Southampton to London Pipeline Project

Response to the Examining Authority's First Written Questions General Questions (GQ)

Application Document: 8.6.02

Planning Inspectorate Reference Number: EN070005

Figure GQ.1.17.1: Key Plan Showing the Existing and Proposed Pipeline Routes along with the relevant planning authority boundary

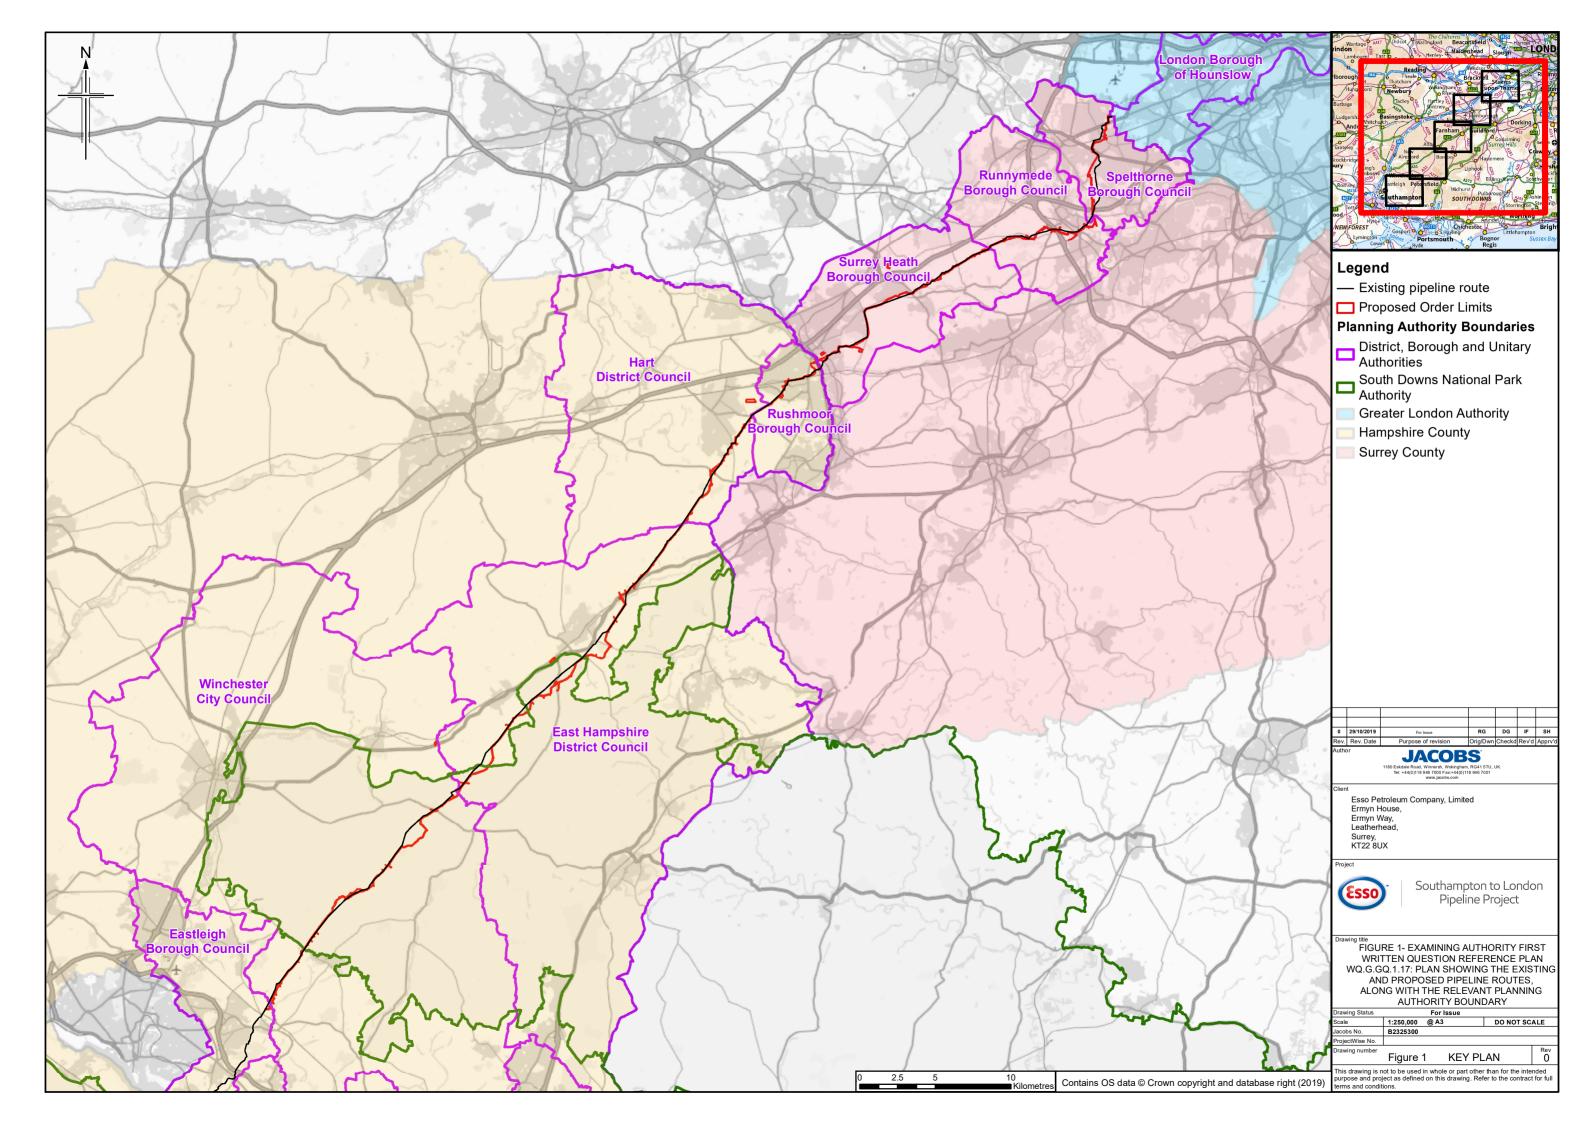
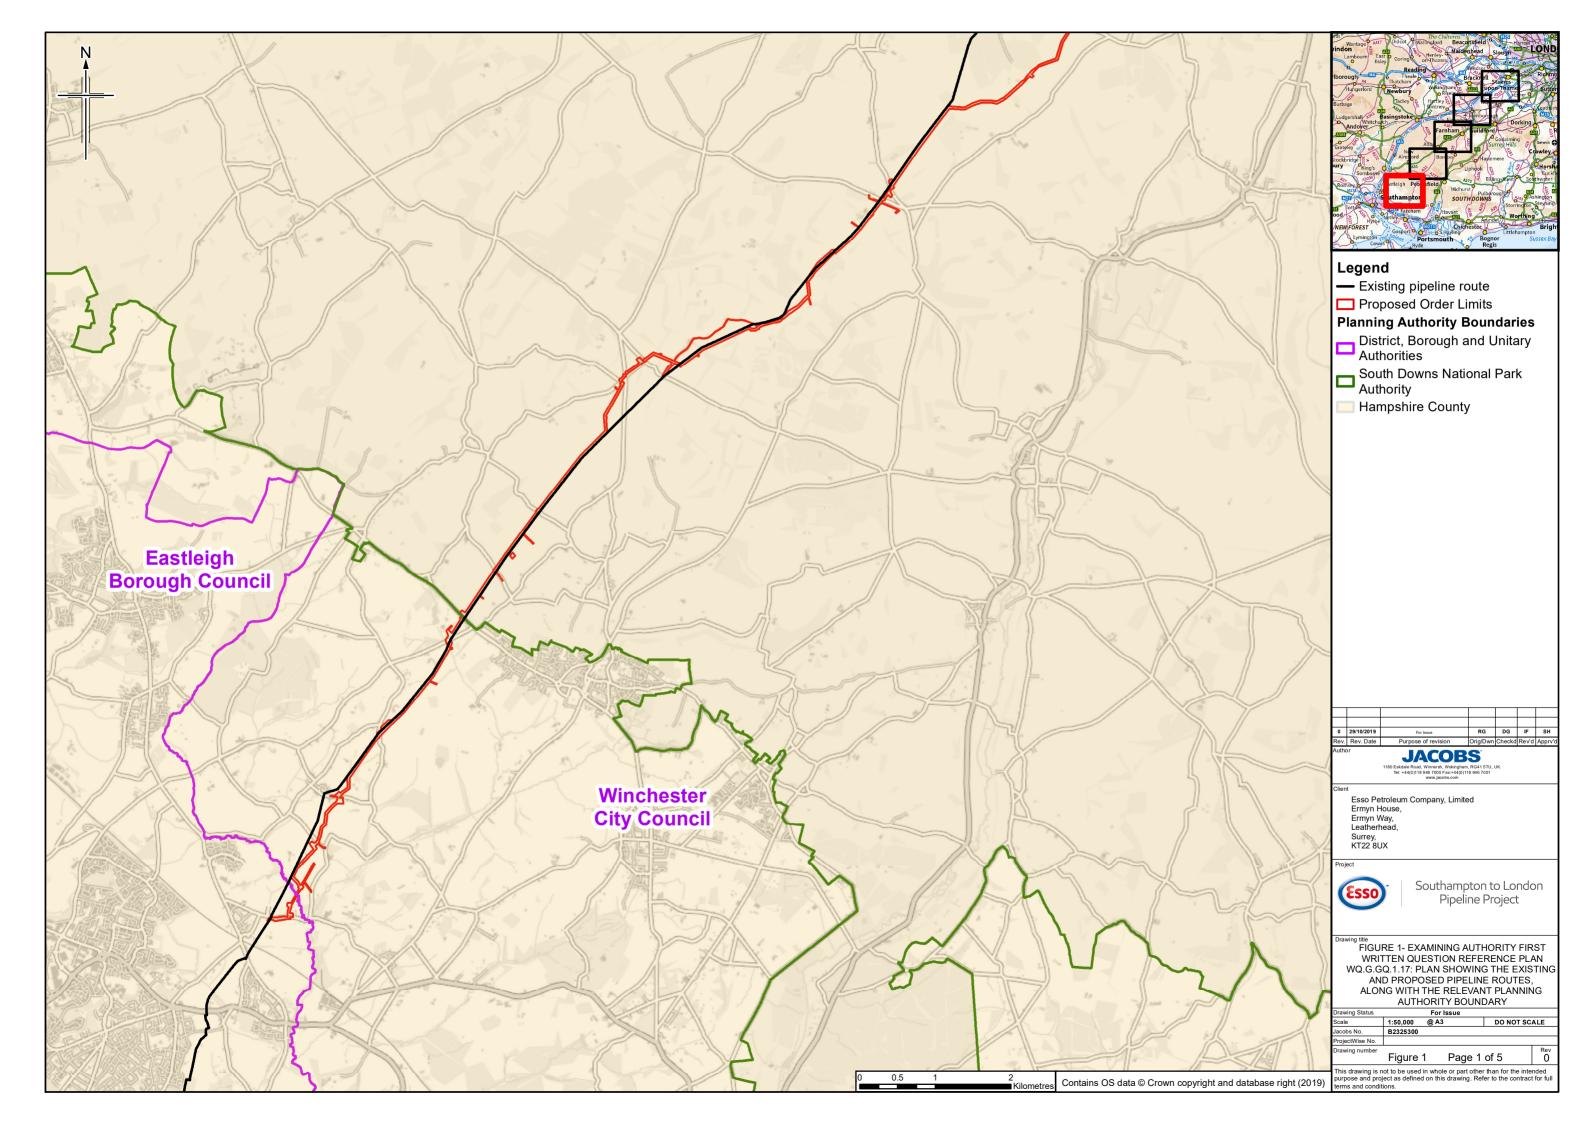
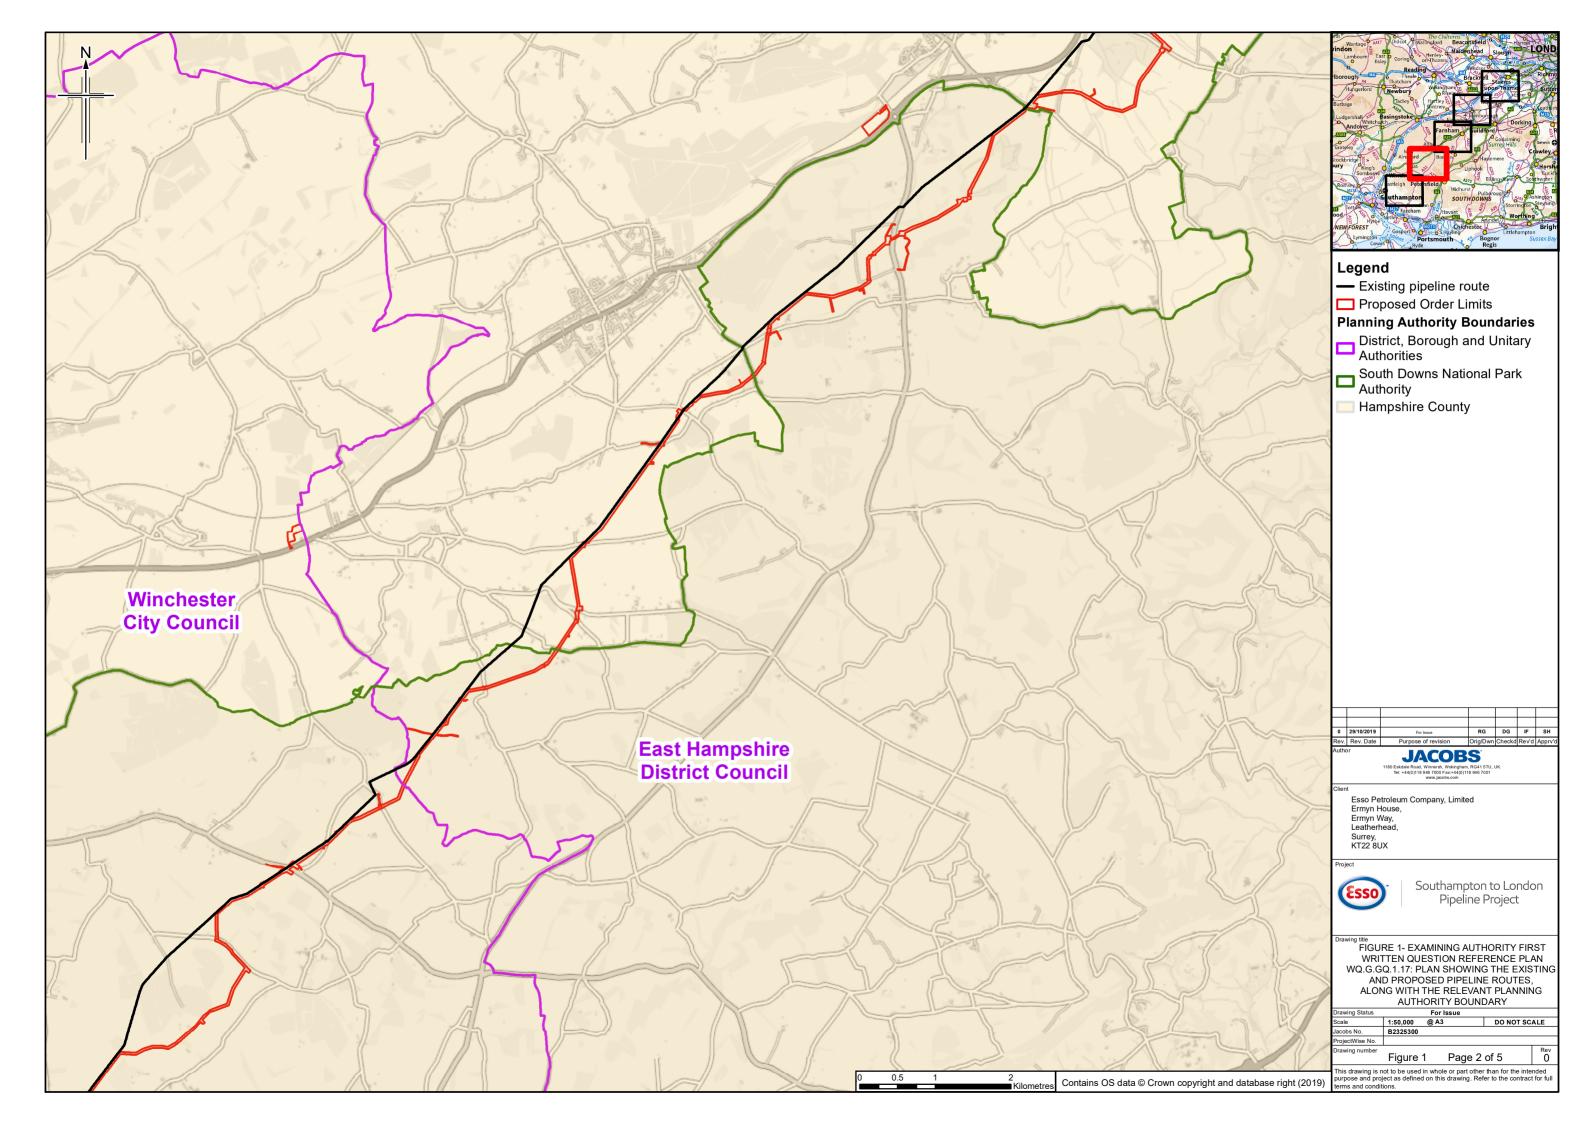
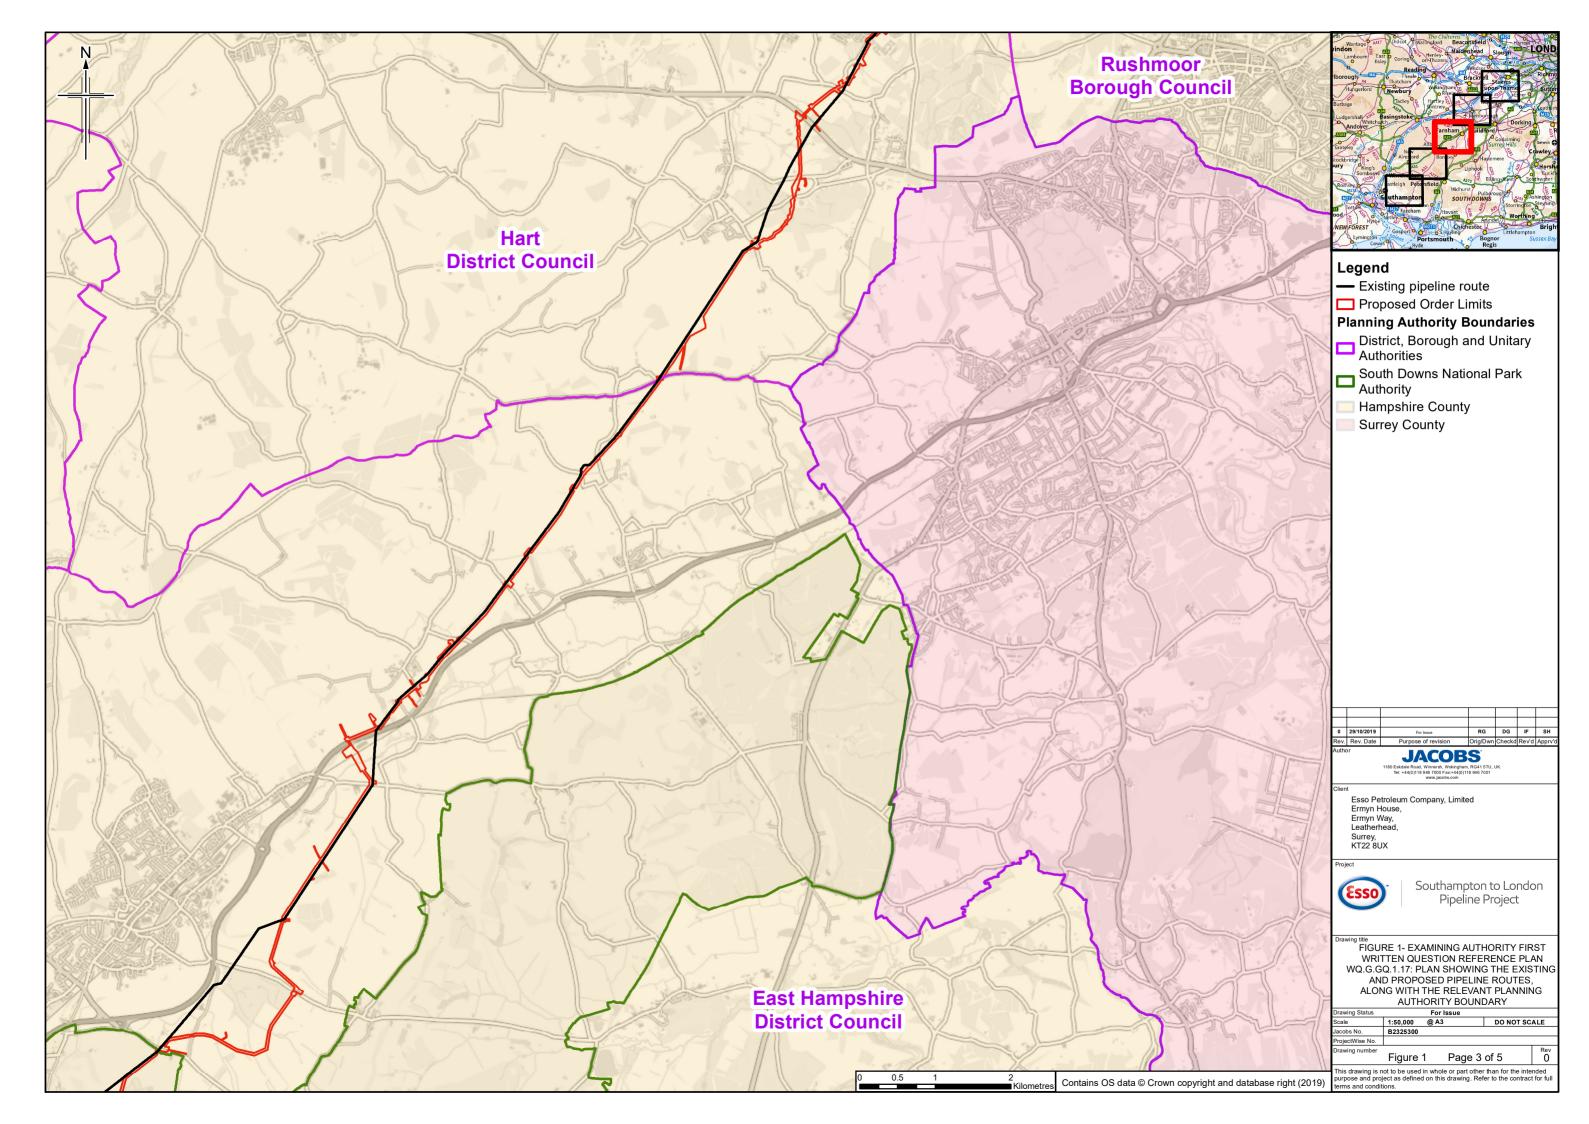
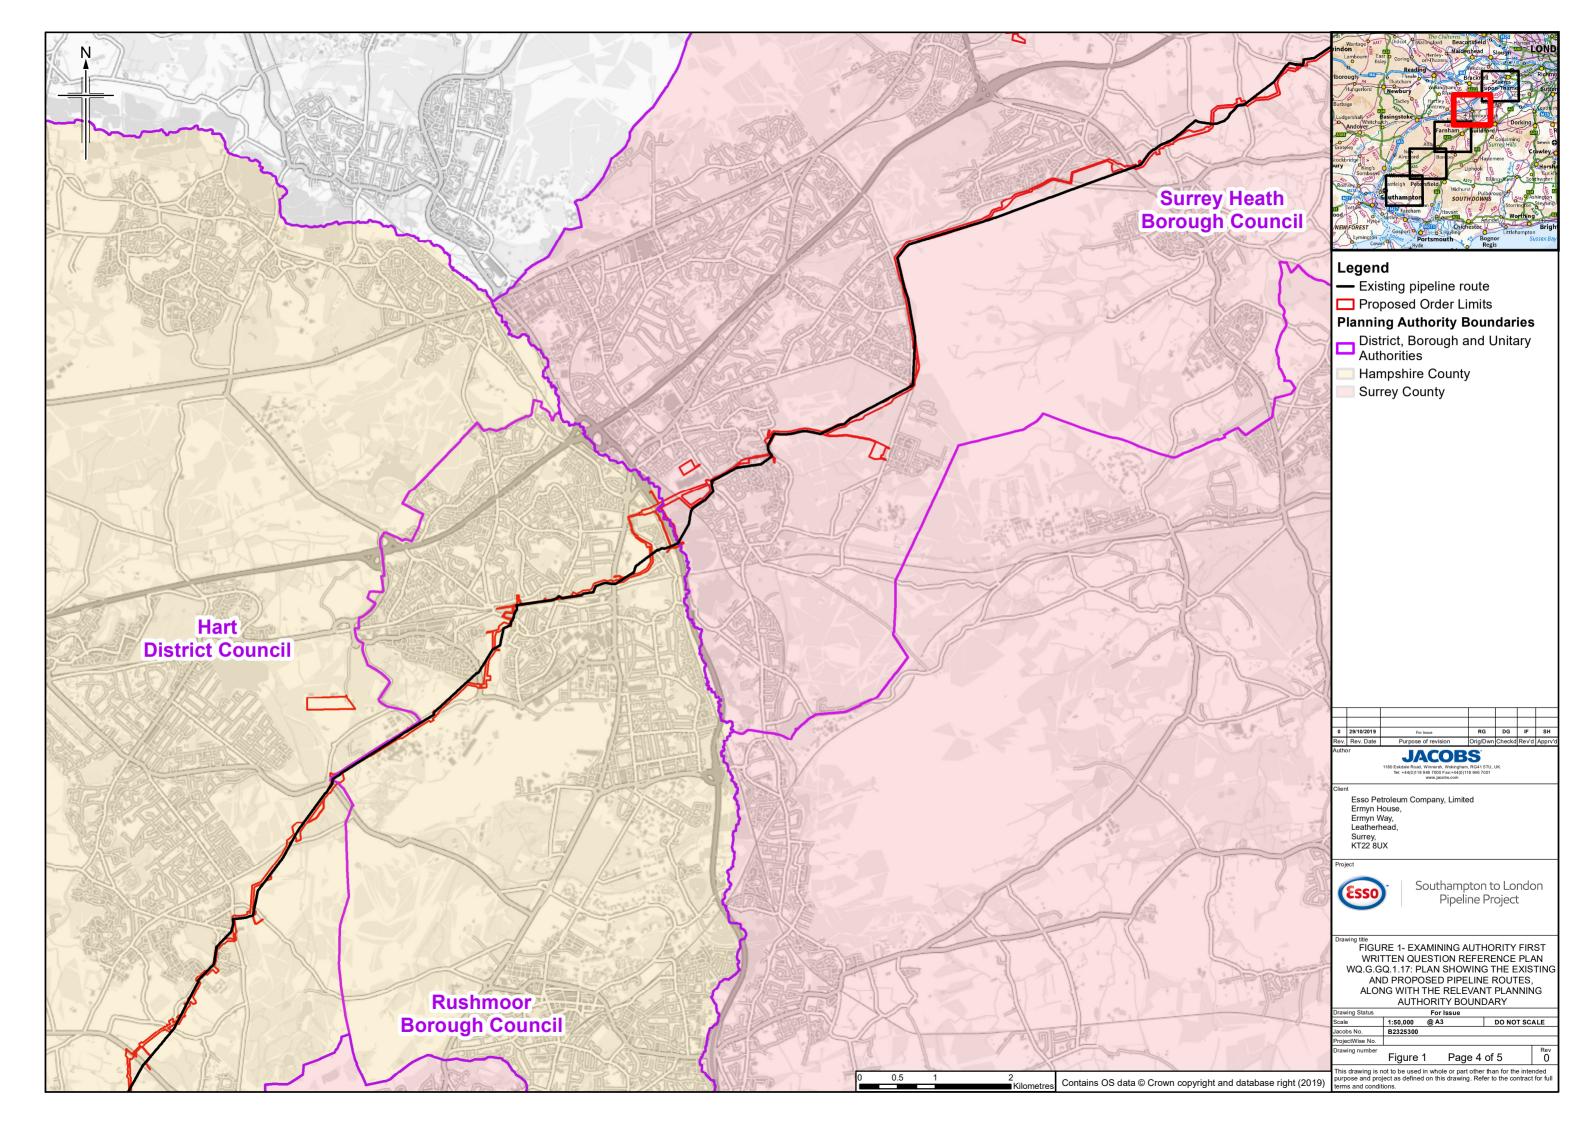
iii) Provide a plan of trenchless crossing areas; or iv) Signpost where this can be found in the	1.4 In response to iv), trenchless crossing area plans are listed in the Register of Environmental Actions and Commitments (Application Document <u>APP-056</u>) and detailed in Annex B of the CoCP (Document Reference 6.4 Appendix 16.1 (2)). Annex B of the CoCP makes clear that the relevant references are also expressed within the General Arrangement Plans <u>AS-056</u> , <u>AS-057</u> and <u>AS-058</u>).
	Application; and v) Explain how this is secured in the draft DCO [AS-059].	1.5 In response to v), compliance with the CoCP (including Annex B) is secured under Requirement 5 of the draft DCO (Document Reference 3.1 (3)).
	N.B – You may wish to combine the response to this question with GQ.1.15 above	
GQ.1.17	Provide a plan showing the existing and proposed route with the Relevant Planning Authority	1.1 A plan showing the existing and proposed route with the Relevant Planning Authority boundaries was not submitted with the Application Documents.

ExQ1	Question:	Applicant response to Question:
	boundaries or signpost where such a plan exists in the Application documents.	1.2 Therefore, plans are submitted to the Examining Authority in response to this question. The main plan (Figure GQ.1.17.1 – Key Plan) shows, at a scale of 1:250,000, the existing pipeline and the proposed Order Limits from Boorley Green to the West London Terminal storage facility, with the Relevant Planning Authority boundaries. This plan is also split into five sheets (Figure GQ.1.17.2 – Sheets 1 to 5) at a scale of 1:50,000, which also show the existing pipeline and proposed Order Limits with the Relevant Planning Authority boundaries in more detail.
GQ.1.19	Chapter 3 of the ES [APP-043] states that the above ground components are, through design and materials, resilient to climate change effects. Explain how this conclusion has been reached and which effects have been considered.	1.1 Section 3.4.1 of the Flood Risk Assessment (FRA) (Application Document <u>APP-134</u>) states that 'the replacement pipeline would be buried underground for its entire length with the exception of the pigging station and smaller elements such as valves, cabinets and marker posts. During the operational phase the buried pipeline has no effect on flood risk and only the above ground infrastructure needs to be considered'.
